**CITY OF COPPELL
PLANNING DEPARTMENT**

STAFF REPORT

Case No.: PD-267R-RBN, Avalon

REQUEST: A zoning change request to PD-267R-RBN (Planned Development-267 Revised-Residential Urban Neighborhood), to allow nine (9) townhouses.

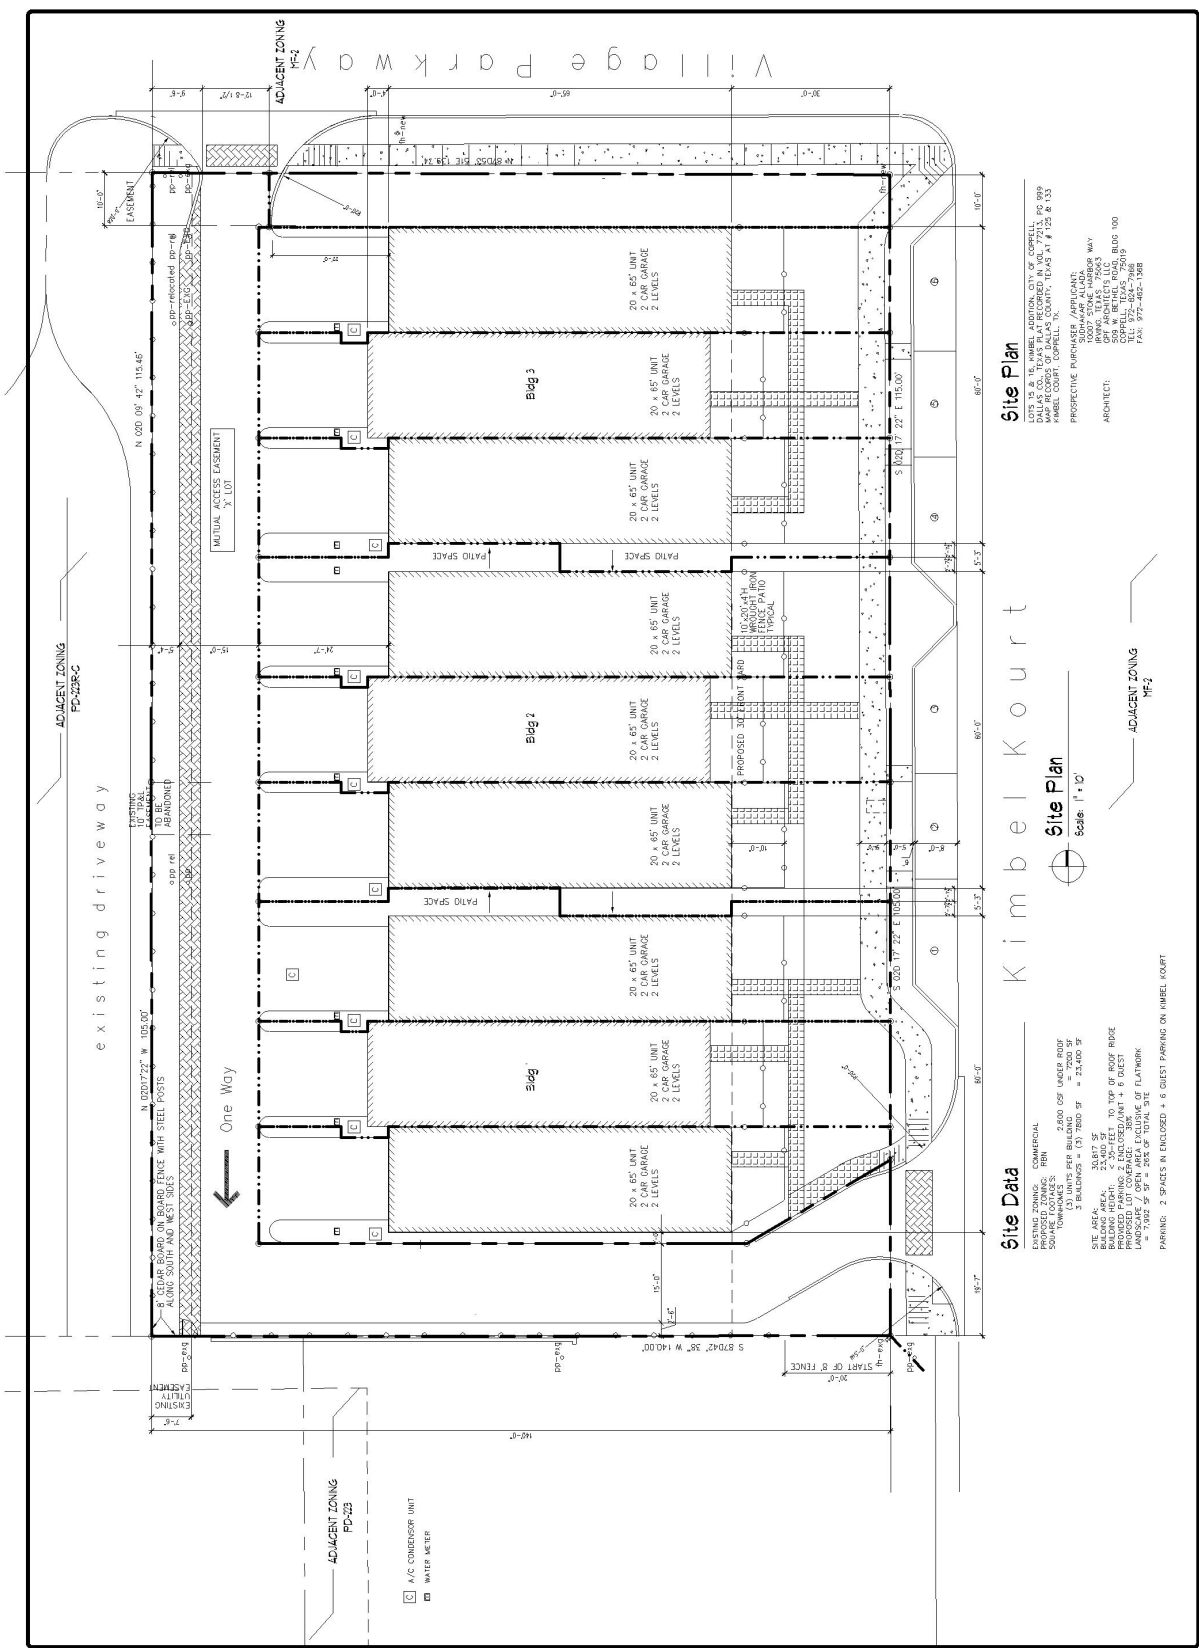
1. There will be additional comments upon detailed engineering review.
2. Resolve the issue with the lot configurations and the placement of air conditioning units and other above ground utility boxes.

3. Include all Common Area (X) Lots on the site and landscape plans, including area calculations of each lot and proposed uses.
4. Add a note specifying that all paving, sidewalks, fencing (wood and wrought iron), on-street parking and landscaping (except the 200 sq. ft. area enclosed with the 42" wrought iron fence) will be maintained by the Homeowners Association.

5. Include all easements existing to remain and proposed easements to the Site and Landscape Plans.
6. Explain the functionality of patio areas between the buildings. Consider increasing the separation between groups of units to a 10 foot minimum.

LANDSCAPE NOTES
SPECIFICATIONS AND
DETAILS

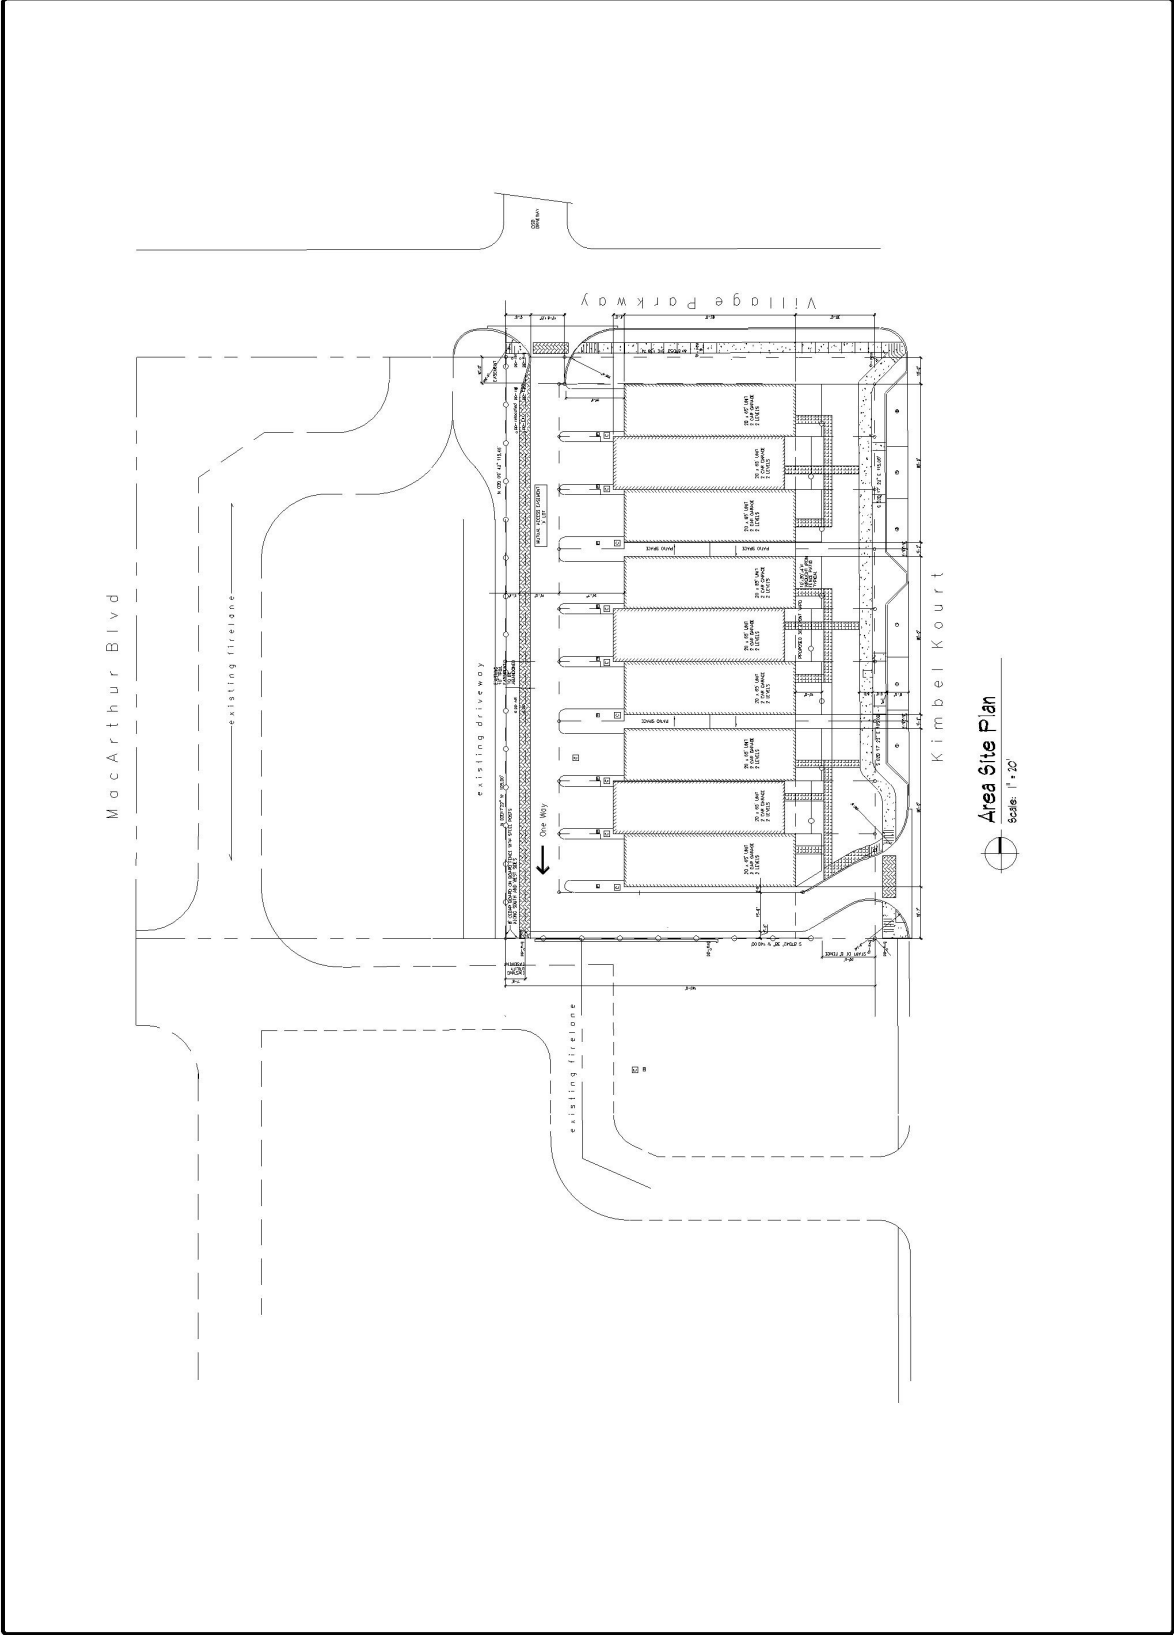
7. Revise the Landscape Plan to replace the Ginkgo trees with another species of overstory tree and relocate them from 3' in front of the building.
8. Revise the building materials to be in compliance with the 80% masonry requirement.

Exterior Masonry Areas

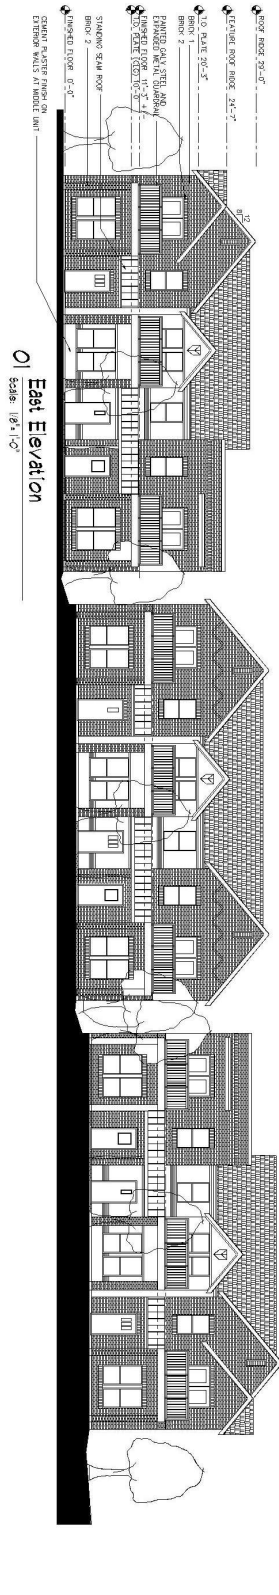
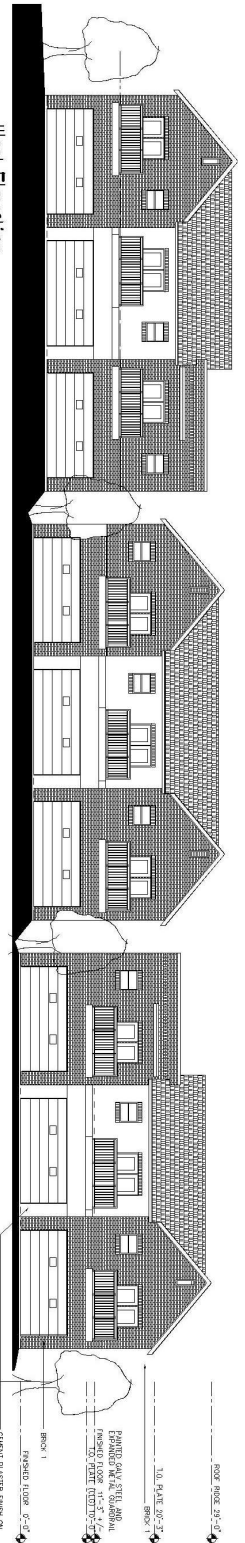
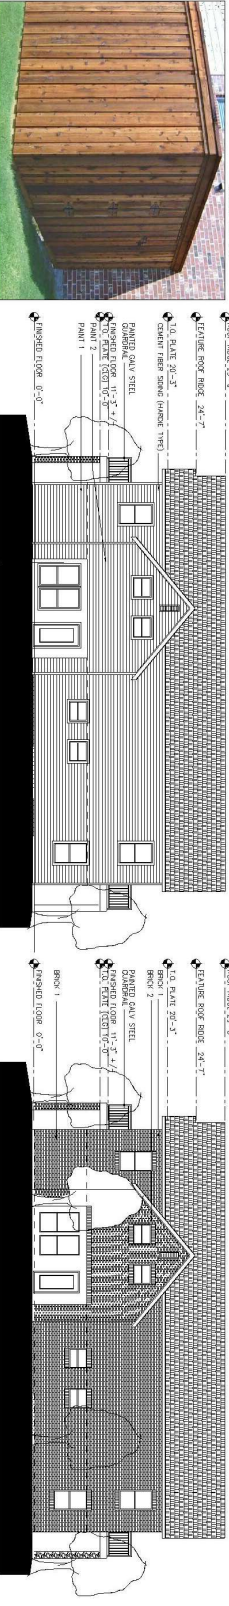
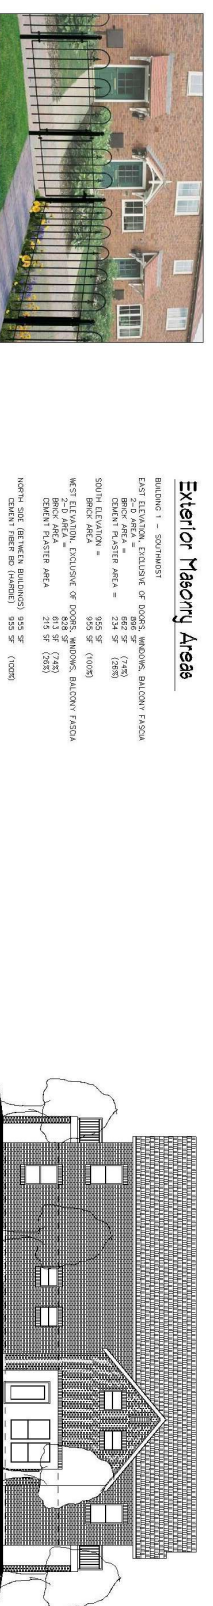
The all zoning districts that permit residential uses (except the Historic District) require 80% masonry exterior. This project is proposing 61.4 % masonry (brick), 12% cement plaster (stucco) and 26.3% cement fiber board (siding). Not only does this not comply with the masonry requirement of the *Zoning Ordinance*, it would not be architecturally compatible with the surrounding commercial, institutional or residential developments. Particularly troublesome is the proposed siding on the elevations between the buildings. Although not readily visible from

the public rights-of-way it will appear substandard and may pose a long term maintenance problem.

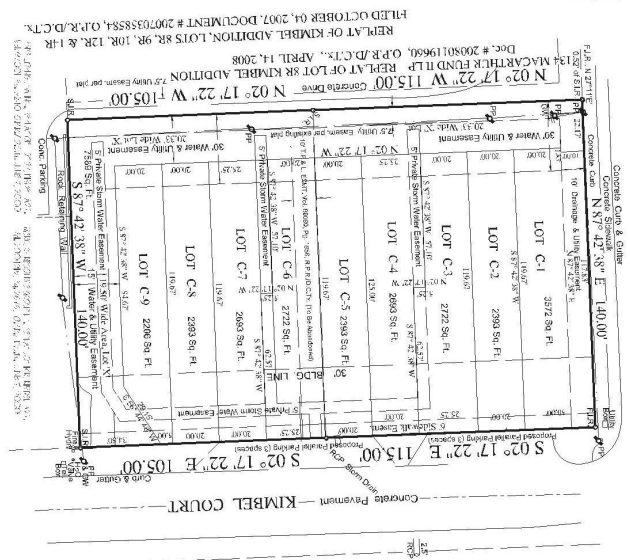
1. There will be additional comments upon detailed engineering review.
2. Title the plat “Kimbel Addition, Lots 1-9, 1X & 2X, Block B” and include it in the City Secretary’s signature block.

3. Revise the Lot numbers to remove the “C-” and add Lots 1X and 2X on the common area lots.
4. Provide verification that the existing power poles will be removed and the T.P.&L easement will be abandoned.

5. Verify the lot sizes, why is there over a 5-foot variation in lot depth between Lots 4 and 5?
6. Accurately locate and label all easements and X-lots, including, but not limited to:

- a. The northern portion of Lot 1 should be a common area (2X) lot with landscape, drainage and utility easements.
 - b. The 15’ alley and abutting landscaped areas also needs to be designated as a common area (1X) lot with landscaping, mutual access and utility easements.

7. Add the right-of-way widths on Kimbel Kourt and Village Parkway.
8. The Replat includes a 6’ sidewalk easement, and the site plan indicates a 5’, which is correct?

9. Correct the spelling of; Council in the City Secretary’s signature block, Tollway in the location map, Court to Kourt, and Frankford in the owner’s address.
